# Response to Submissions Report

## Removal of North Bridge

SSD 7874 MOD 6, SSD 49295711 MOD 8 & SSD 49653211 MOD 1

26 February 2026 | 2210627

**Figure 1** Darling Drive and Murray Street intersection ownership

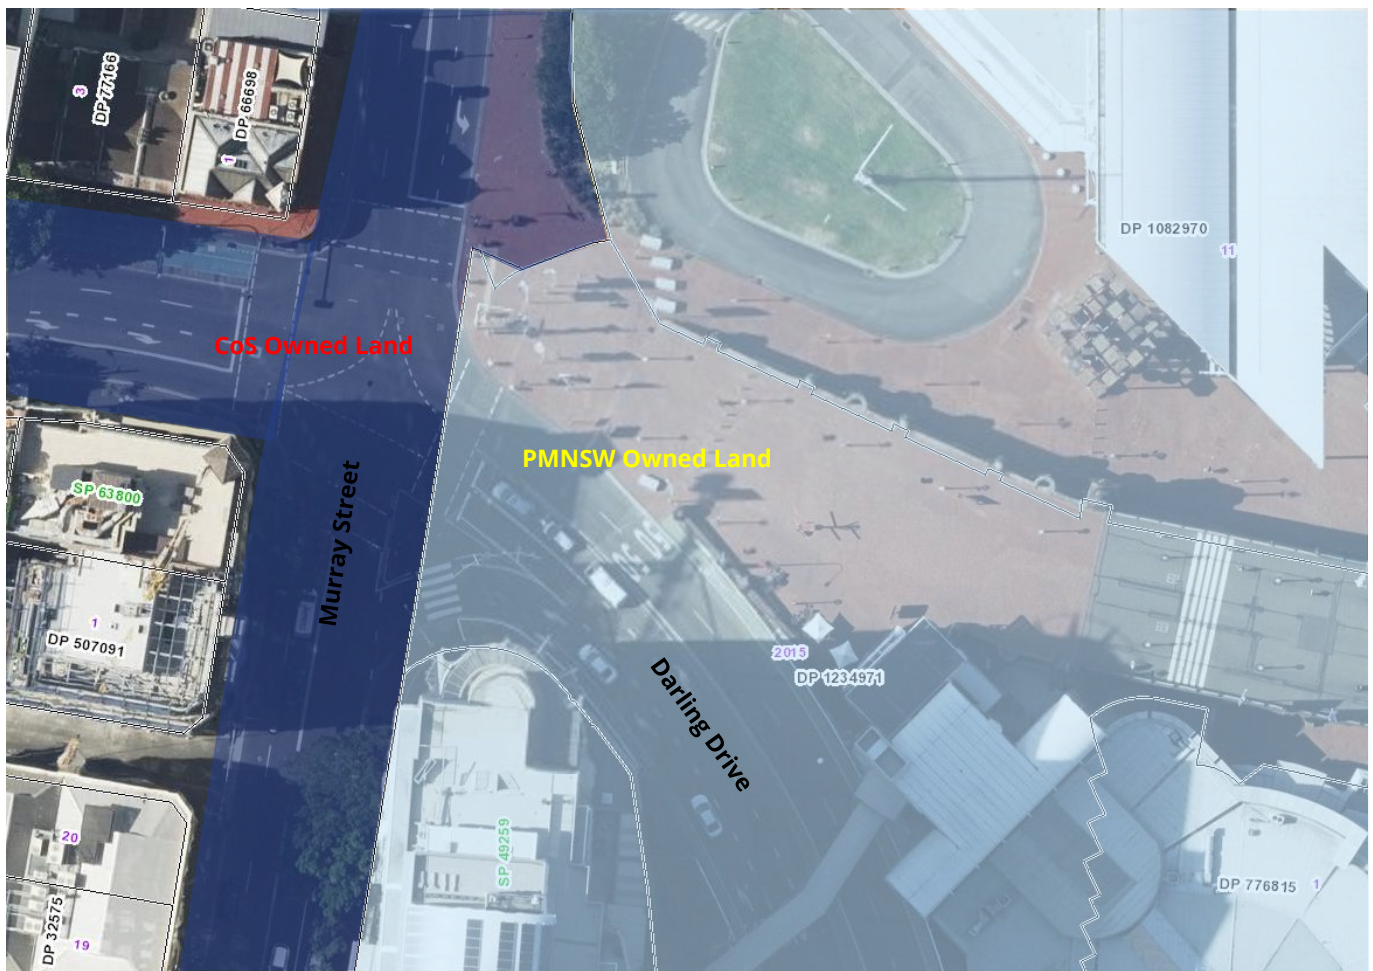
Category	Item	Response
	Confirm ownership of Murray Street and Darling Drive and obtain owners consent if necessary.	Ownership of the Murray Street and Darling Drive intersection is shared between PMNSW and Council (refer to <b>Figure 1</b> below) with TfNSW being responsible for operating and making any changes to the traffic signals. The relevant owners consent for works within the road reserve, in accordance with the proposed condition above, will be sought and provided through the consultation process with TfNSW, PMNSW and Council.
<b>Heritage and Archaeology</b>	Continue to liaise with Heritage NSW and confirm whether the recommendations of the Addendum to the Archaeological Research Design (ARD) Harbourside Shopping Centre, Darling Harbour, by Curio Projects, dated November 2022 remain relevant to the modification application.	The relocation of the pedestrian lift will not result in any additional ground disturbance compared to the project as approved. The location of the lift sits behind the previously approved façade line and therefore does not extend the project disturbance area any further than beyond current approvals.  Therefore, the recommendations of the Addendum to the Archaeological Research Design (ARD) Harbourside Shopping Centre, Darling Harbour, by Curio Projects, dated November 2022 remain unchanged for the project as amended.
